Process Sheet

Customer : CU-DAR001 Dart Helicopters Services	Drawing Name : BASKET RIB
Job Number : 48491	
Estimate Number : 10402	
P.O. Number :	Part Number : D31661
This Issue : 11/06/2009 S.O. No. :	Drawing Number : D3166 REV.A2
Prsht Rev. : NC	Project Number : N/A
First Issue : // Type : LARGE FAB ASSY	Drawing Revision : A2
Previous Run : 48425	Material :
Written By :	Due Date : 17/06/2009 Qty: 12 Um: Each
Checked & Approved By : <u>JUD 09-06-11</u>	
Comment : Est. A 02.08.23 New issue KJ	
Est. B 08.12.05 Updated bending program on step 3 per NCR	
W/O43165 KJ Verified by: EC	
Est Rev:C 09-01-23 as per DEO D3166-A2 DD verified by:EC

DESIGN #	DRAWN BY CP	DART AEROSPACE LTD HAWKESBURY, ONTARIO, CANADA	
CHECKED #	APPROVED #	DRAWING NO. D3166	REV. A SHEET 1 OF 1
DATE 02.07.10		TITLE BASKET HOOP	SCALE NTS
A	02.07.10	NEW ISSUE	
A1	04.04.08	38+/-1 WAS 36.0

DRAWING NO. D3166	TITLE BASKET HOOP	REV.A1	DART AEROSPACE LTD ENGINEERING ORDER		D.E.O. NO. D3166-A-2	SHEET NO. 1 OF 1	SCALE NTS
DRAWN AJS	CHECKED [Signature]	MFG. APPR. [Signature]	APPROVED [Signature]		DE APPR. [Signature]		
DATE 08.12.11	DATE 08.12.15	DATE 08/12/15	DATE 08/12/16		DATE 08.12.16

D3166-1 BASKET HOOP

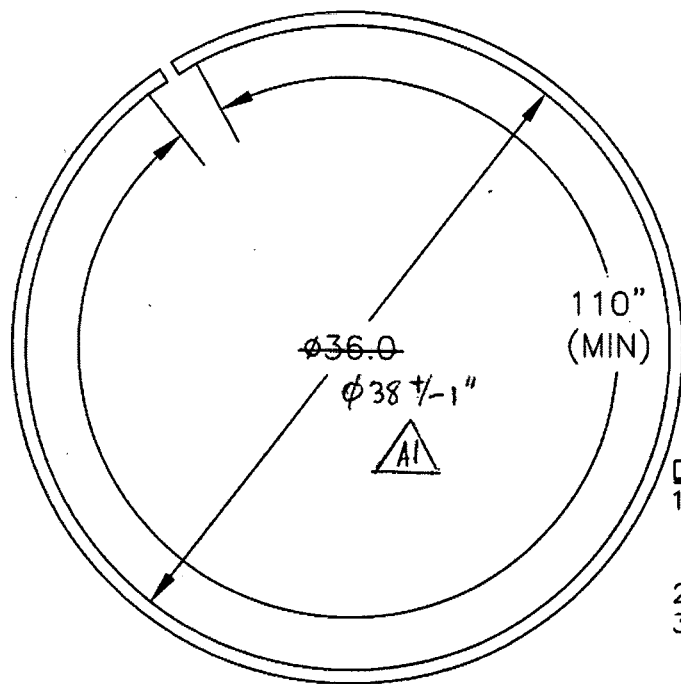
1) MODIFY MATERIAL NOTE FOR D3166-1 AS SHOWN:

IS:

- 1) MATERIAL: AISI 304/316 SS, 3/4 X 3/4 X 0.065 WALL SQUARE TUBING,
60.00" LONG
REF. DART SPEC M304TS0.750W.065

WAS:

- 1) MATERIAL: AISI 304/316 SS SQUARE TUBING,
0.75" x 0.75" x 0.063 WALL, 60.00" LONG
(REF DART SPEC. M304TS0.750W.063)
